ADDENDUM NUMBER 001

Date: April 6, 2026
EDR Project No.: **21004**

COPA LIFEGUARD HEADQUARTERS
303 Ninth Street
Port Aransas, Texas 78373

Addendum 1-1
EDR Project No. 21004
04/06/2026

REGISTERED PROFESSIONAL ENGINEER
STATE OF TEXAS
ROBERT ENRIQUEZ MARTINEZ
89387
MECHANICAL
EXPIRATION DATE 08/25/2020

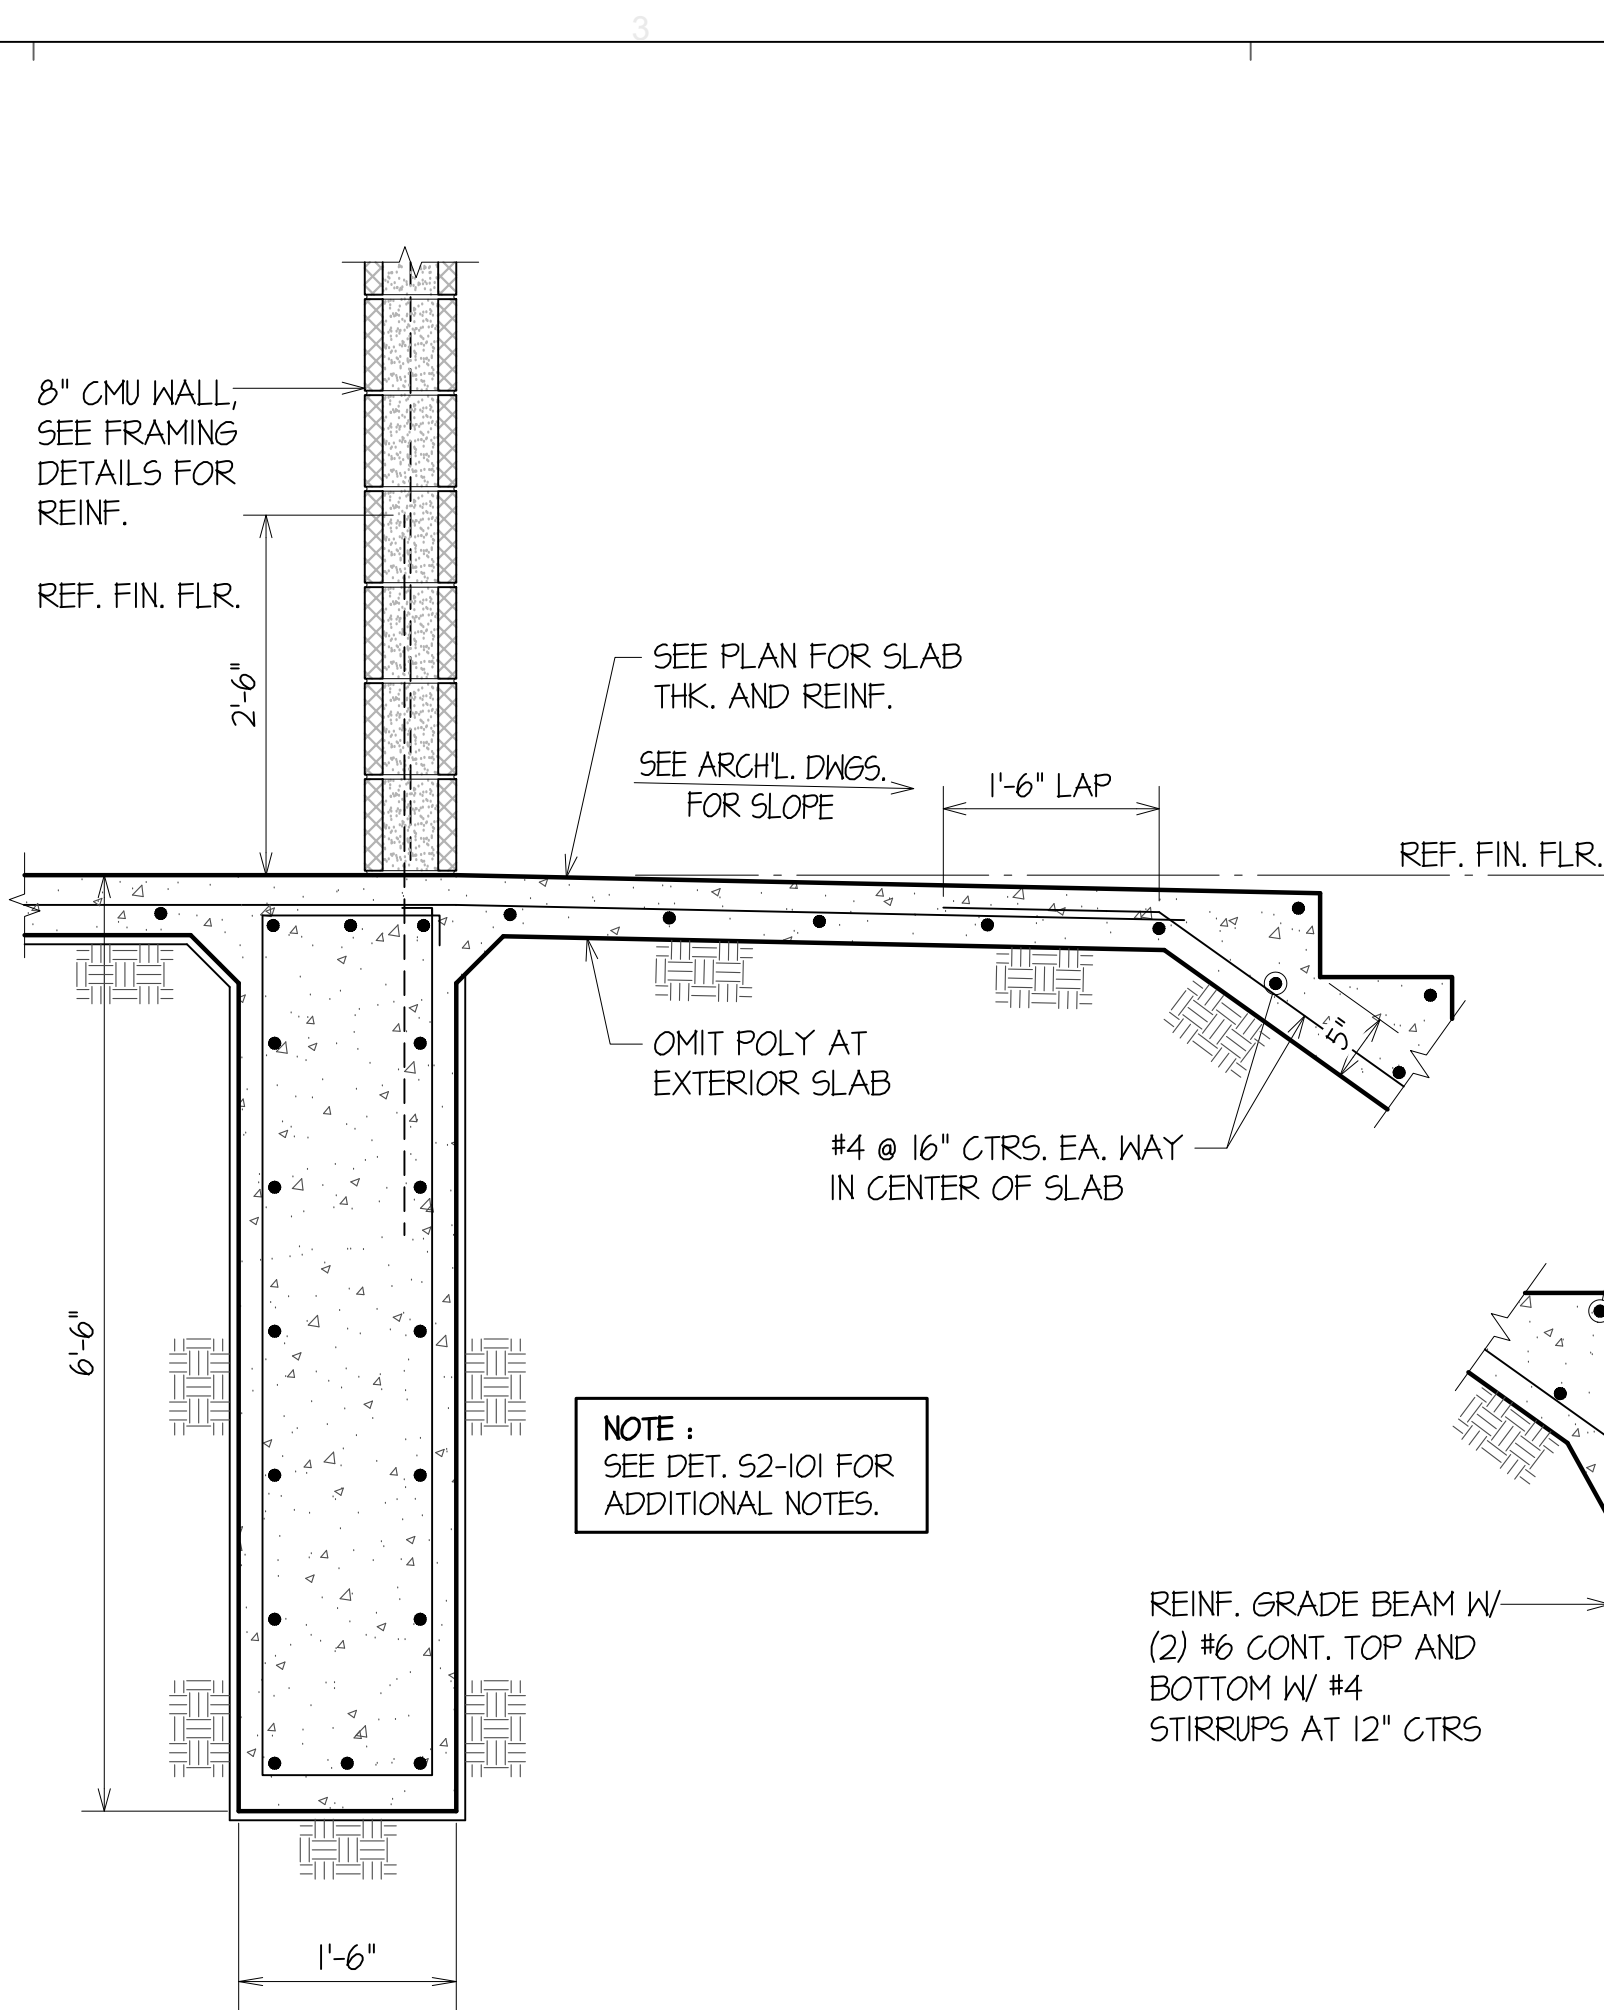
Sheet S1-1 – Foundation Plan and Roof Framing Plan

- a.) Hanger channel and details added at change in roof elevation along Grid 4.
- b.) Uplift and wall pressure diagram added to plan.
